U.S. NUCLEAR REGULATORY COMMISSION

Reports No. 50-373/94003(DRS); 50-374/94003(DRS)

Type of Meeting: Enforcement Conference

## LASALLE COUNTY STATION ENFORCEMENT CONFERENCE

### LaSalle Station SRV Setpoint Performance Frequency Distribution

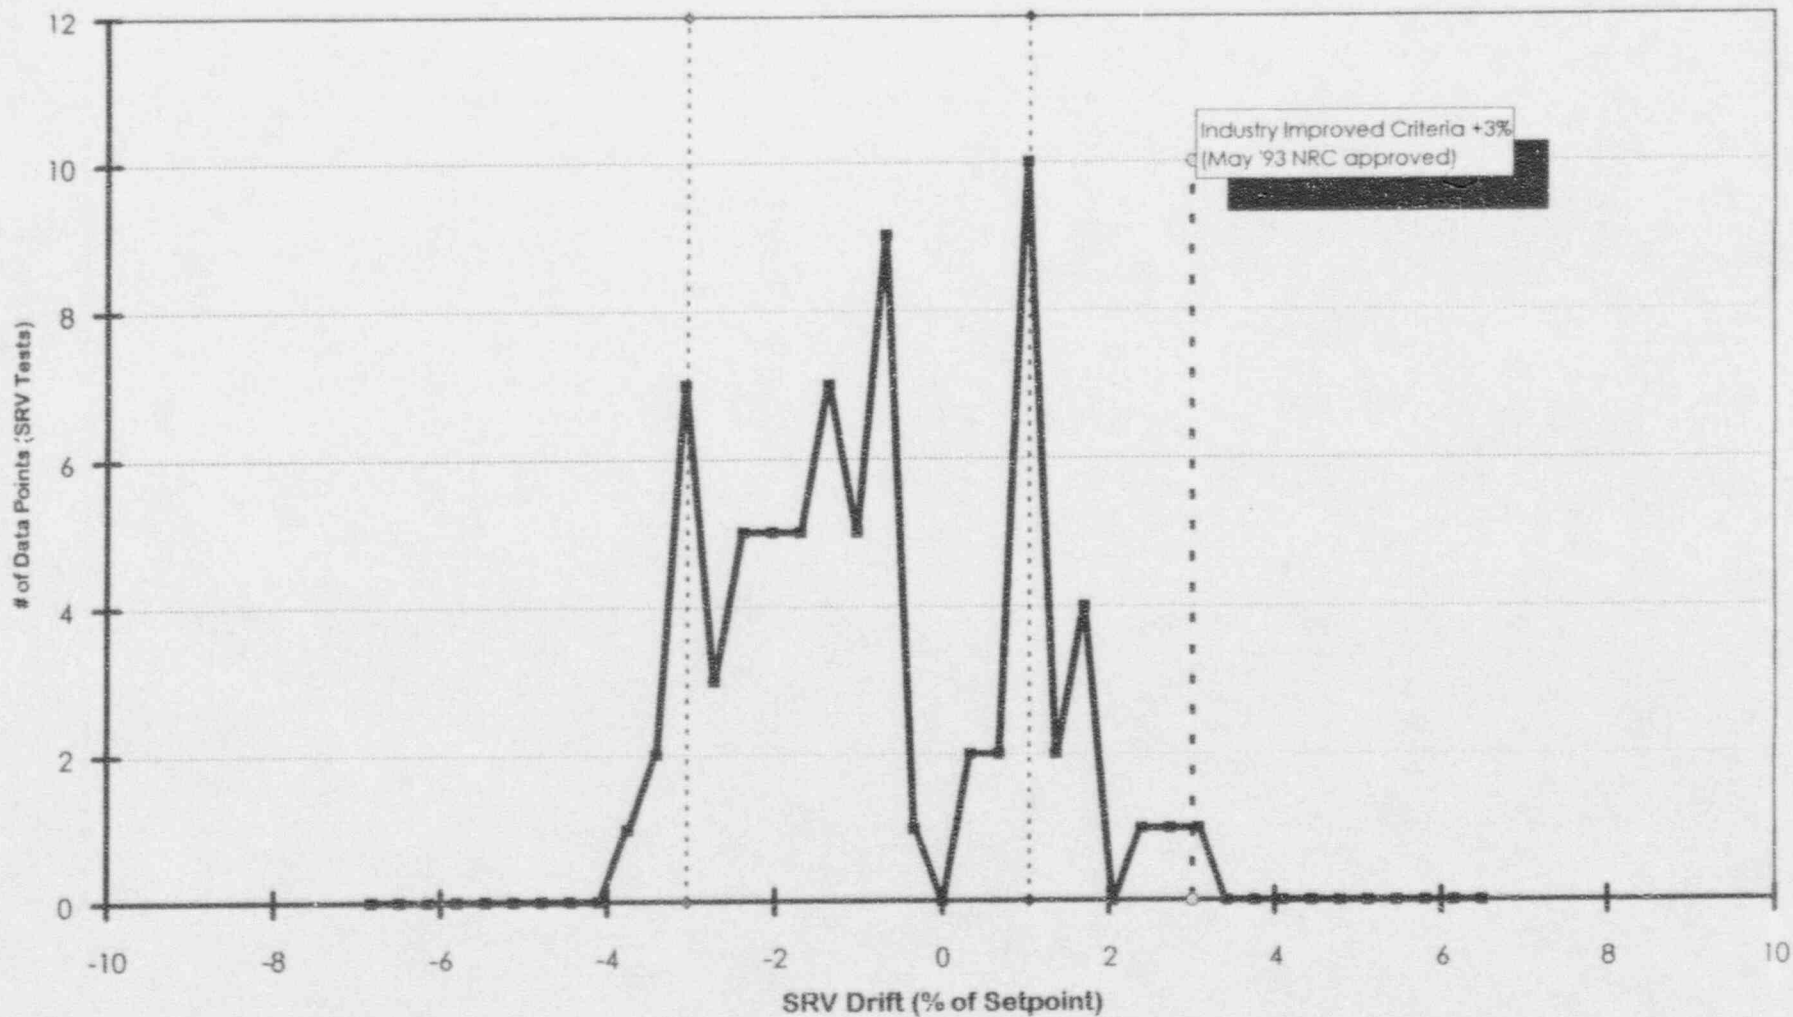
### ■ SRV SETPOINT DRIFT

- Data comparable to Industry/Crosby valves
- Positive Drift < ASME OM1 (improved) criteria of +3%
- Negative drift caused by leakage
